PLAN COMMISSION

February 14, 2023

AMENDED

Proposal: Plan Review – Multitenant Industrial Building

SIGN CRITERIA - BUILDING ELEVATIONS

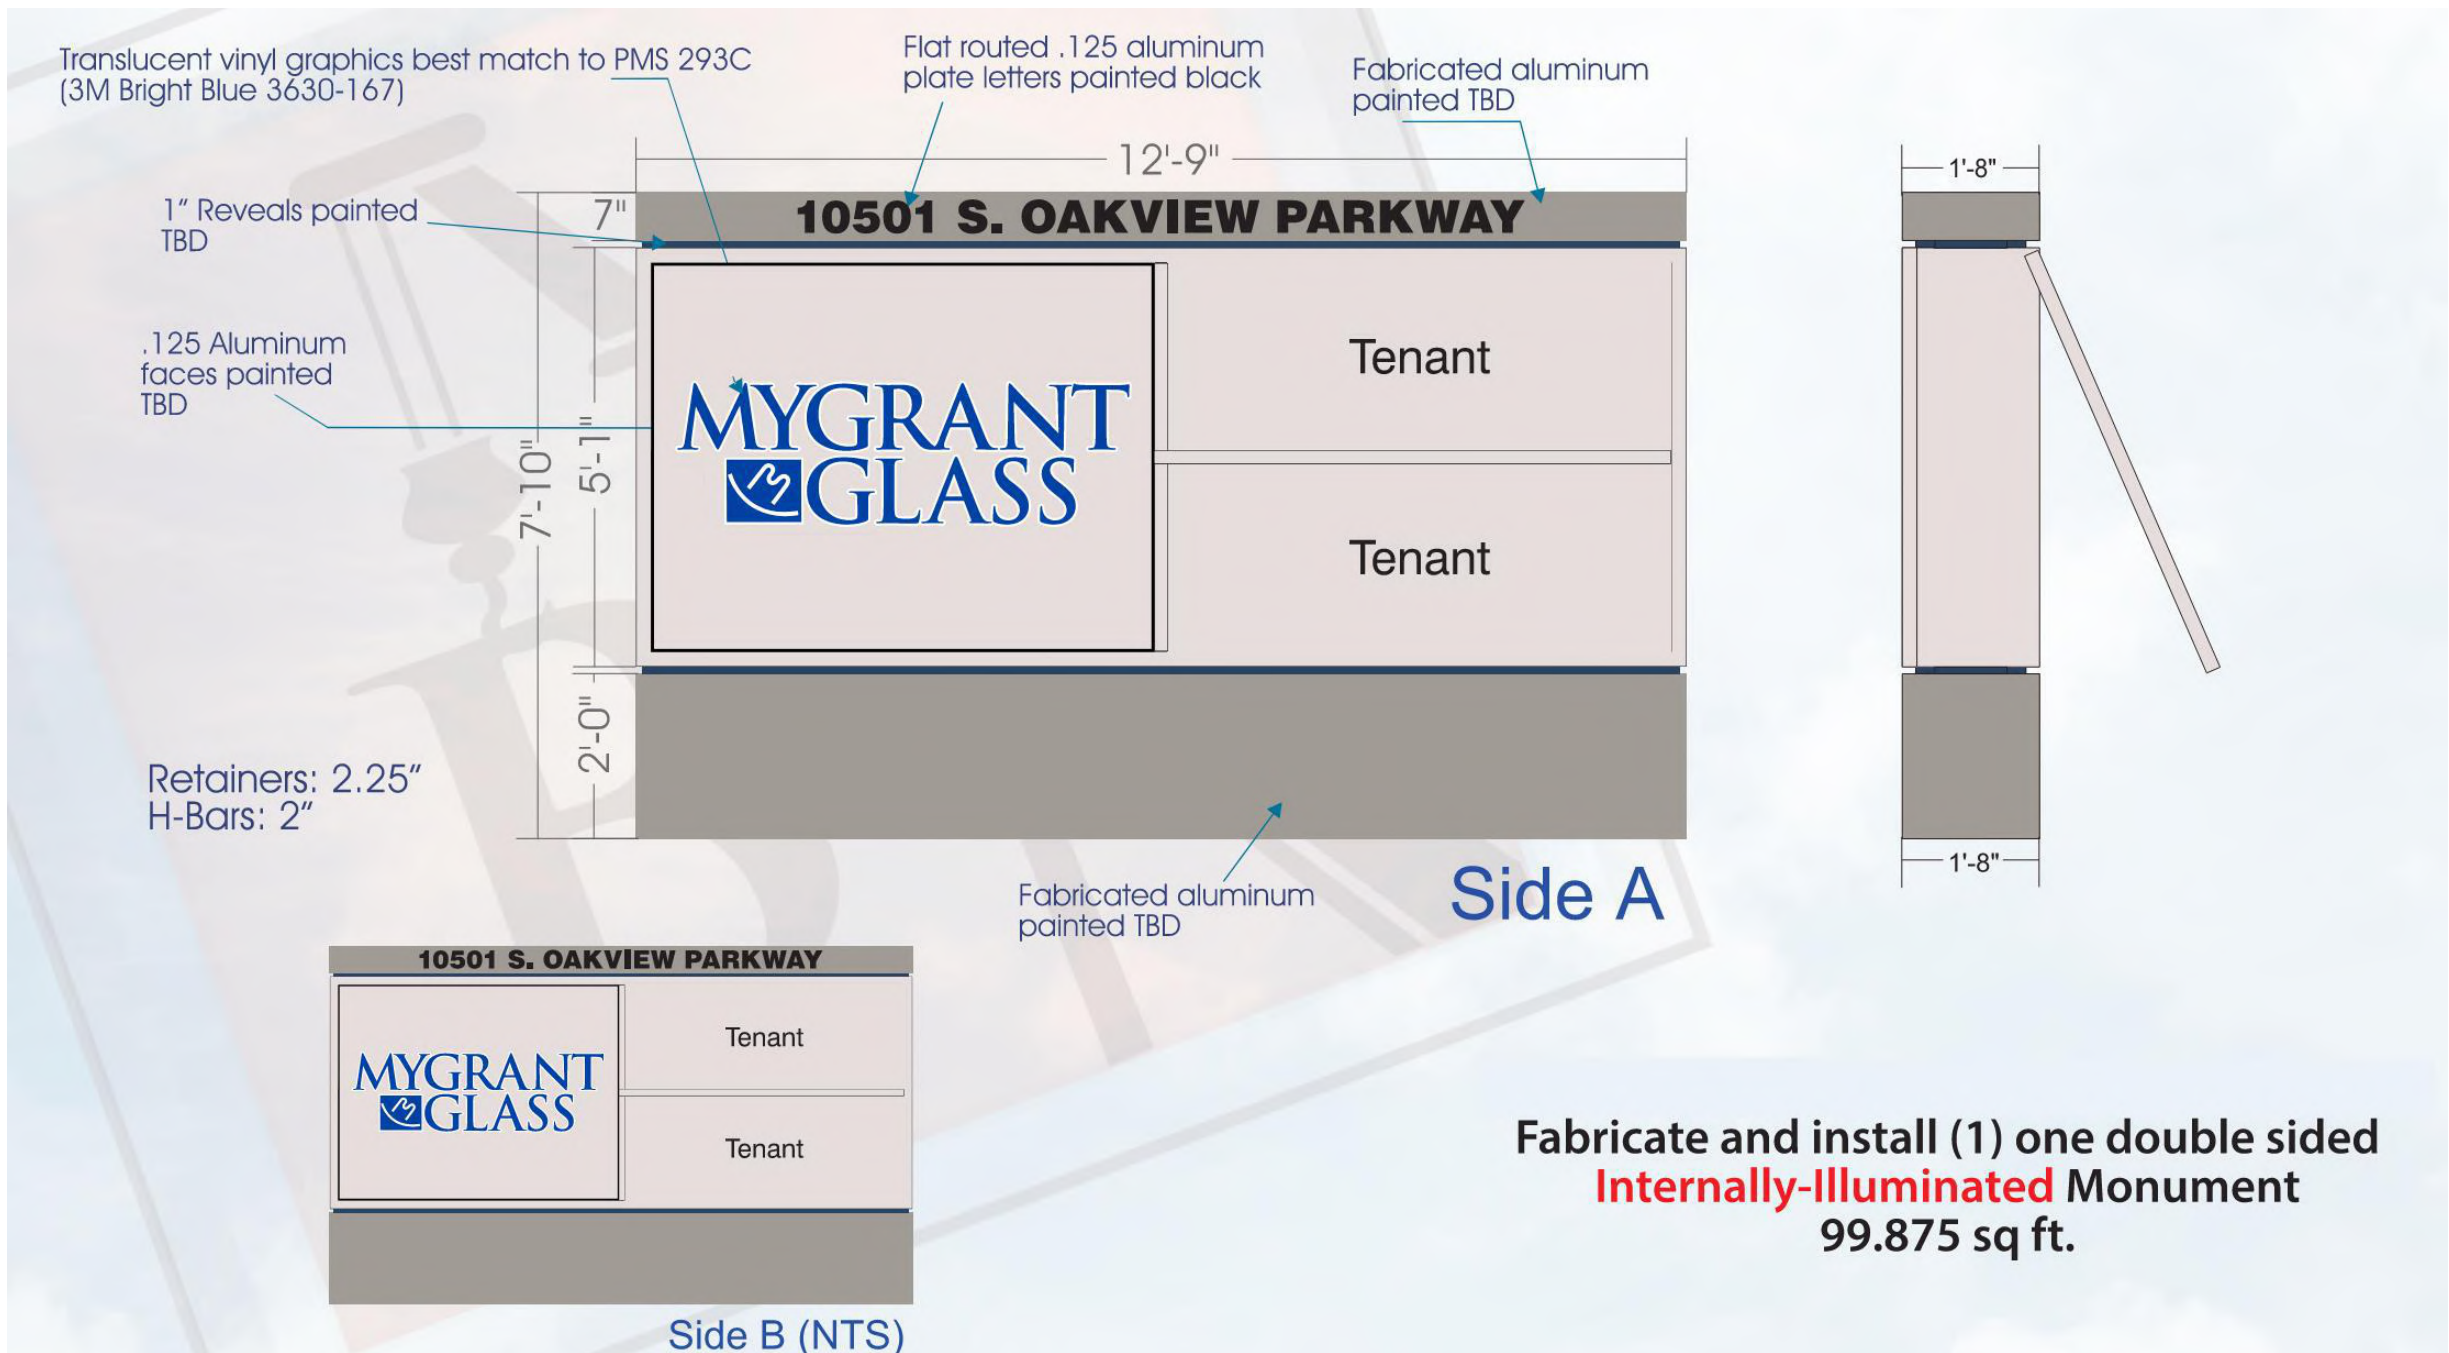
1. That all relevant Code requirements remain in effect.
2. That the monument sign base is revised to meet Code requirements for width and materials.
3. That permits are issued for signs prior to installation. The Master Sign Plan shall become null and void if sign permits associated with all signs included in the Master Sign Plan have not been issued within 12 months of the date of approval (February 14, 2024 **UNLESS OTHERWISE DETERMINED BY THE PLAN COMMISSION**).
4. That all detailed, revised, and finalized plans are submitted in digital format to the Department of Community Development prior to submission of permit applications.

Lastly, one (1) 12’ 9” x 7’ 10” monument sign is proposed on the east side of the property. The location, outside of easements and a minimum of 10 feet from the property line/public right-of-way, meets all setback requirements. The approved landscape plan for this development included plantings around the future monument sign. The following require revision or specific Plan Commission approval:

SITE DIMENSION AND PAVEMENT ID PLAN

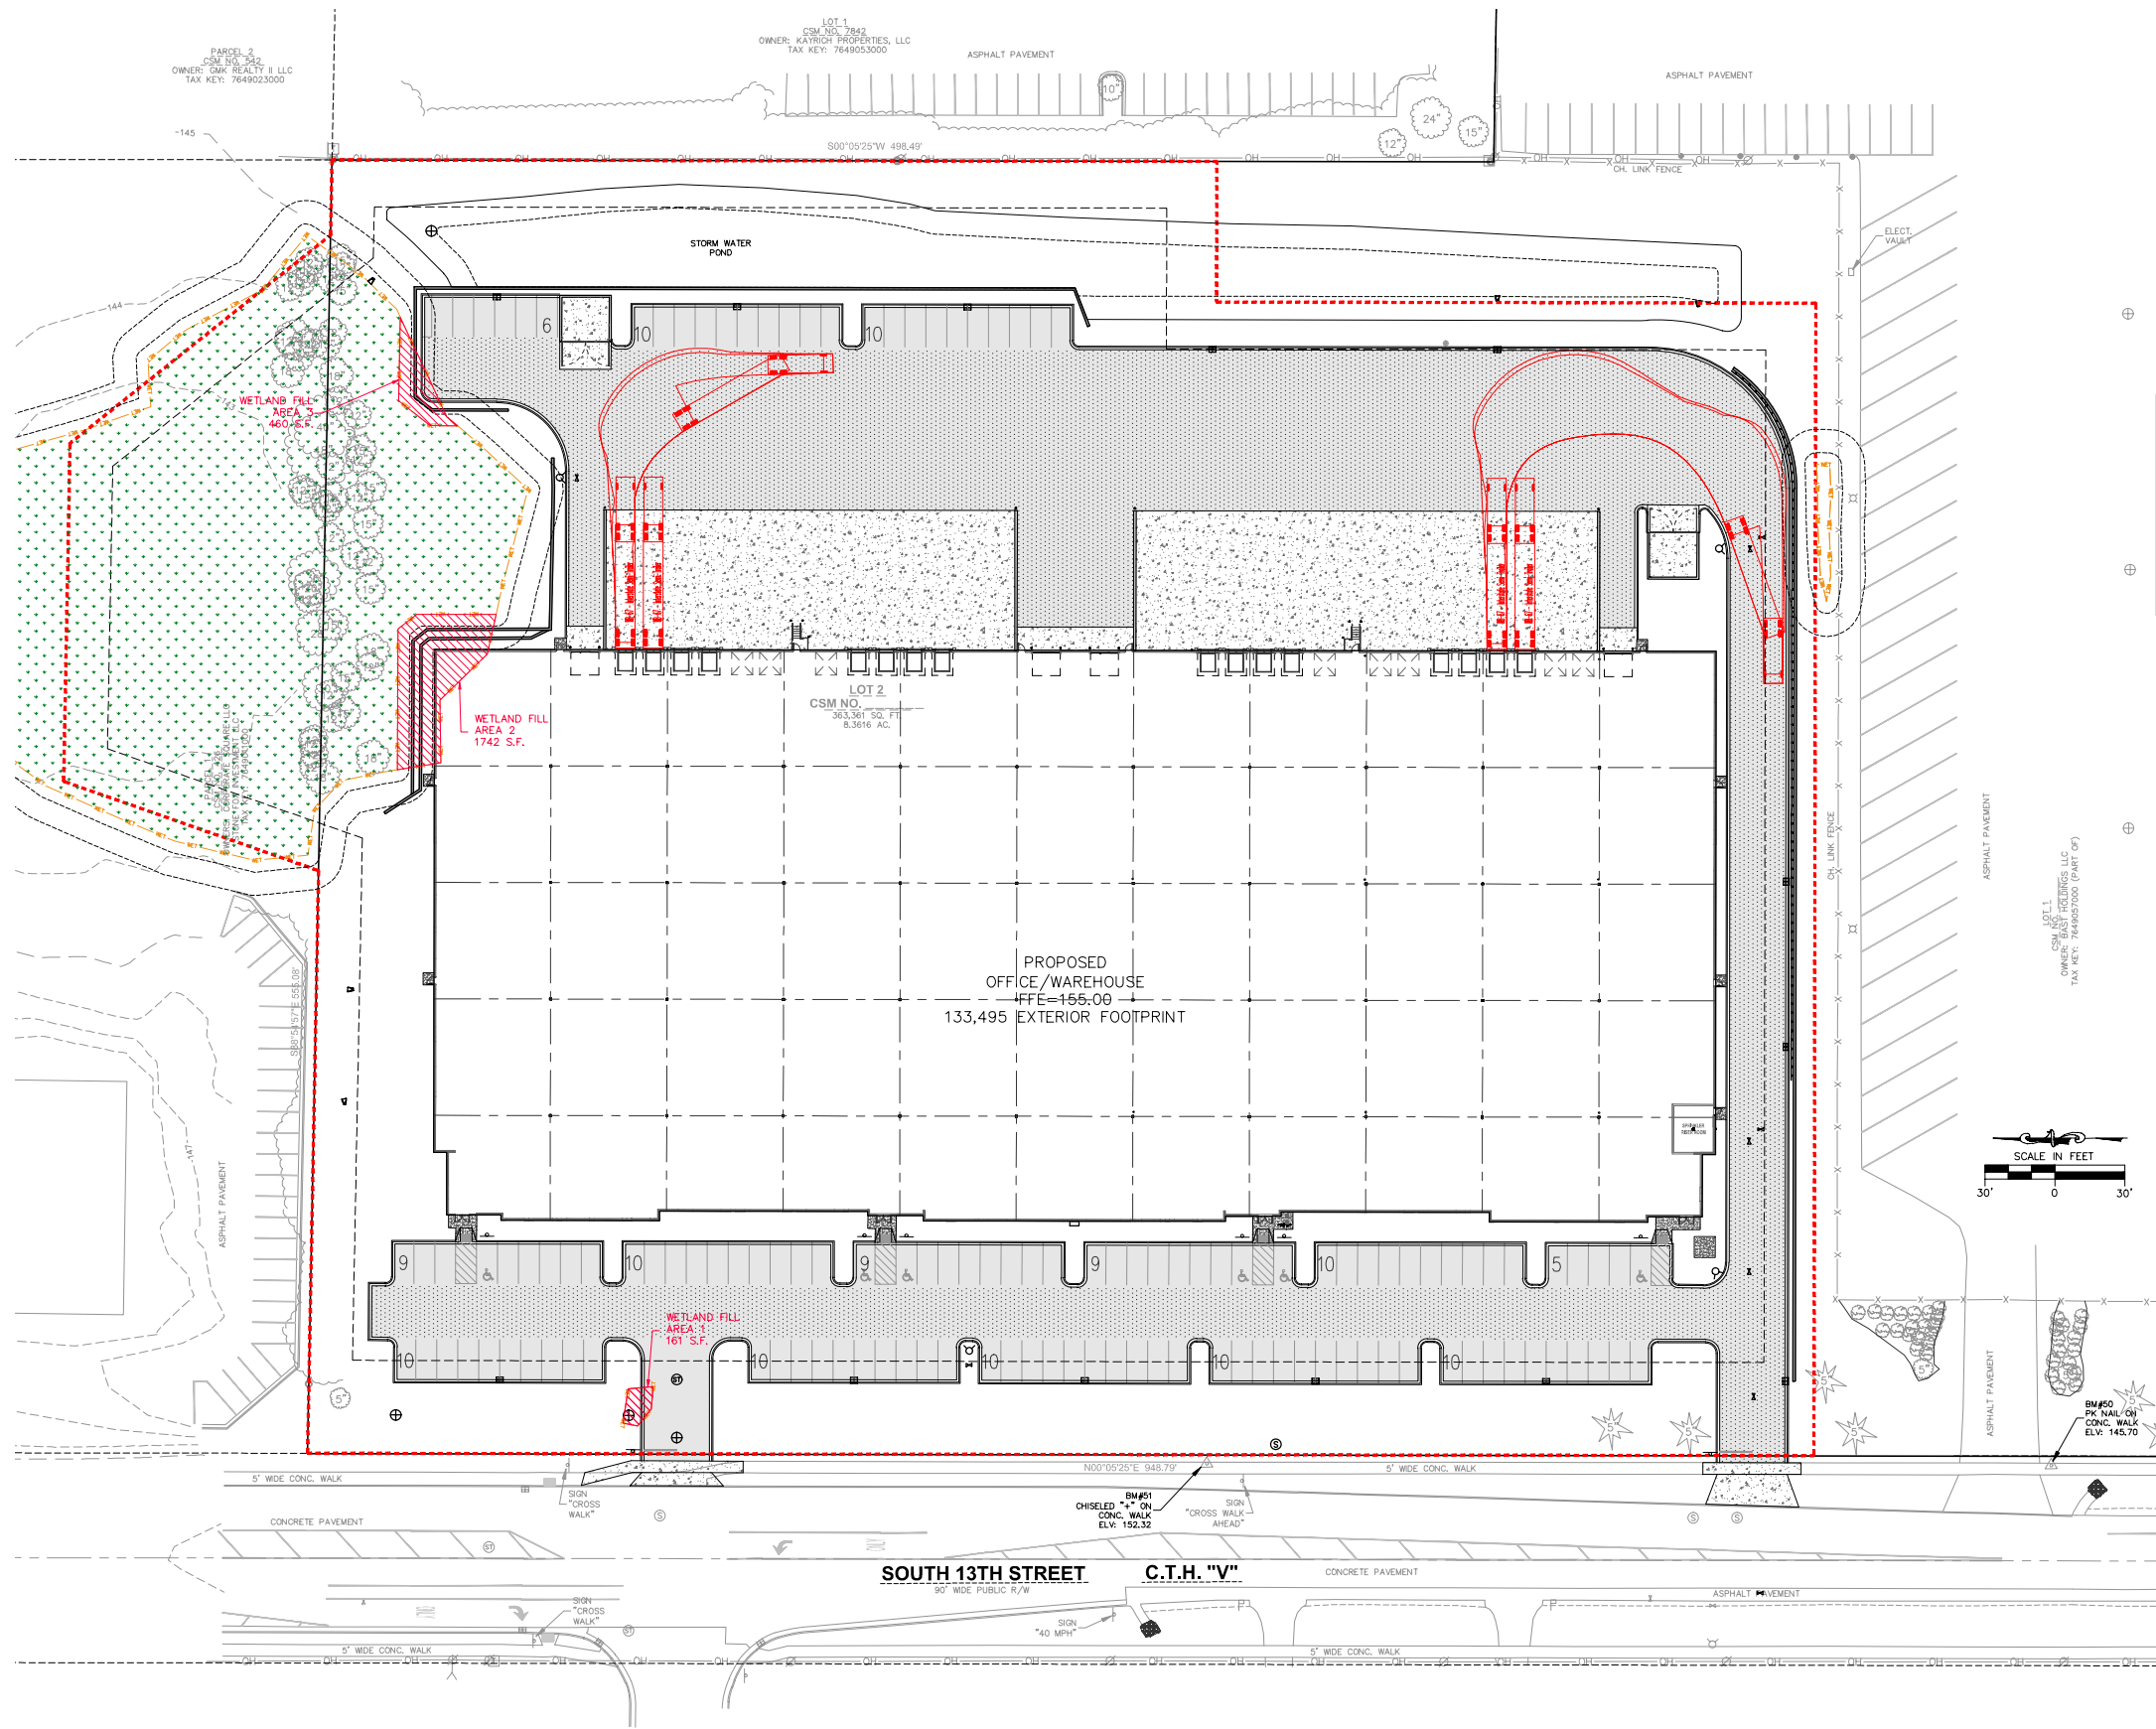
- Reduced wetland fills on the north.
- Slight relocation of the building south.
- Reduced pavement and parking area on the northeast. Parking for the site is now shown at 128 stalls versus 132 in previous plans. Loading area doors on the north were reduced to a total of 11 total versus 14 in previous plans. The trash enclosure on the north was relocated to the parking area.
- Addition of a “no parking” area on the south side of the north loading area per Fire Department requirements.
- Addition of retaining walls on the north.
- Updated floor plans provided.

Following the submission of staff comments a few of the plan sheets received further revisions. However, those revisions did not carry through the remaining plans. All plans will be required to match prior to submission of permit applications. Staff also noticed that the floor plans include a location identified for a “tank/pit area” with no further detail. This must be clarified to determine compliance with all Fire and Zoning Code requirements. Lastly, staff still have the same comments previously mentioned regarding the landscape and tree preservation and replacement plans:

Thank you for providing commentary on the above-mentioned project resubmittal dated 1/17/23. Please see RESPONSES in blue from Briohn Land Development, LLC (the “Developer”) and revised Sheets C2.0 and C2.2 in connection with the written responses.

RESPONSE: The 5’ City Undisturbed Buffer (green) and 15’ City Bulk Setback (pink) are identified on the plans submitted 1/17/23. In the area of question, the eastern building façade is 15’ off the wetland, thus the setback line work and building line work overlap.
